CNRO-2005-00054

SUBJECT: Grand Gulf Early Site Permit Application Revision 1 Corrections (TAC NO. MC 1378)

**GGNS ESP APPLICATION - REVISION 1 CHANGE SUMMARY  
PART 4, EMERGENCY PLANNING INFORMATION  
(CORRECTED)**

ESP APPLICATION PART 4, REVISION 1  
CORRECTED PAGES

Figure 3-1 (1 page)

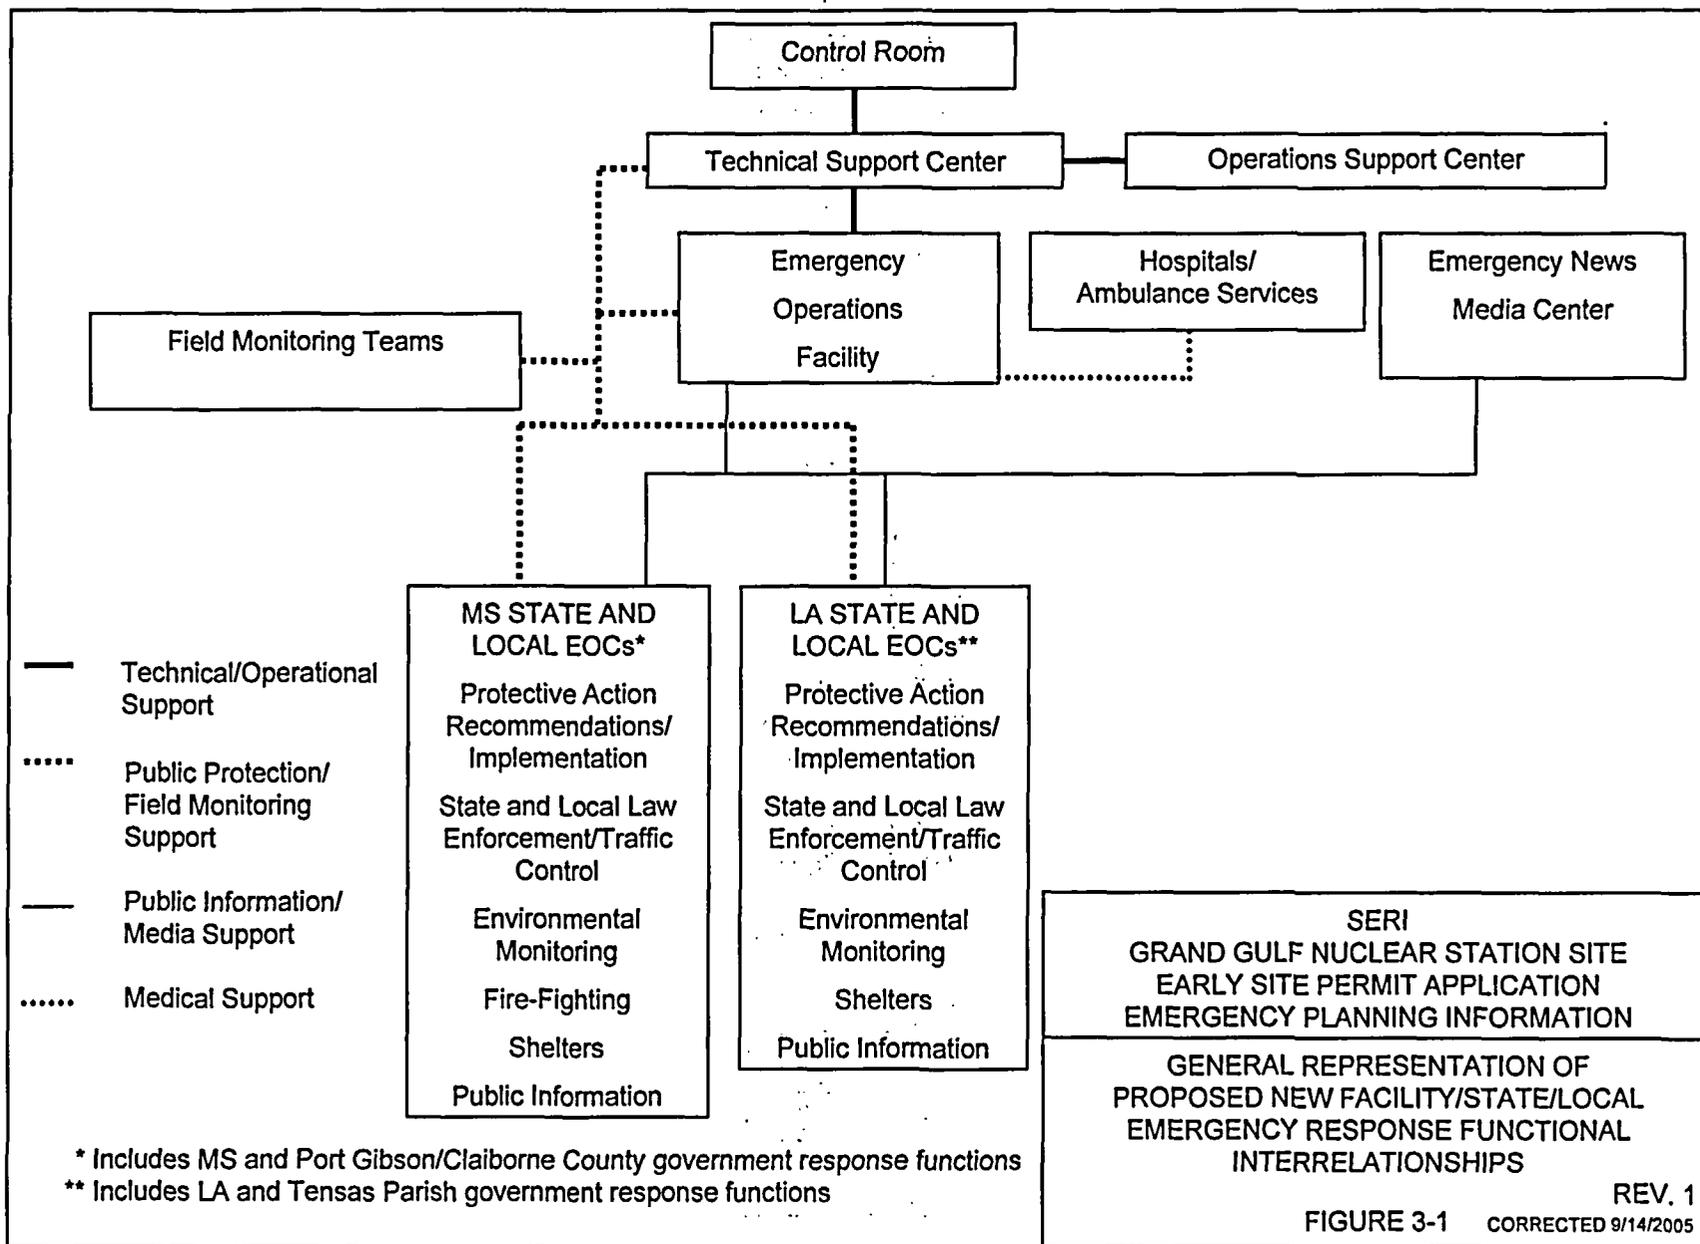
**Action #2:** Provide justification for deleting changes made to Figure 3-1 and Table 4-1 in draft Revision 2 made to address RAIs 13.3-13 & -57, or restore changes identified in draft Revision 2.

The version of Figure 3-1 and Table 4-1 in the draft Revision 2 document should have been incorporated into the Revision 1 files. They were inadvertently omitted. Corrected Tables are included with this letter.
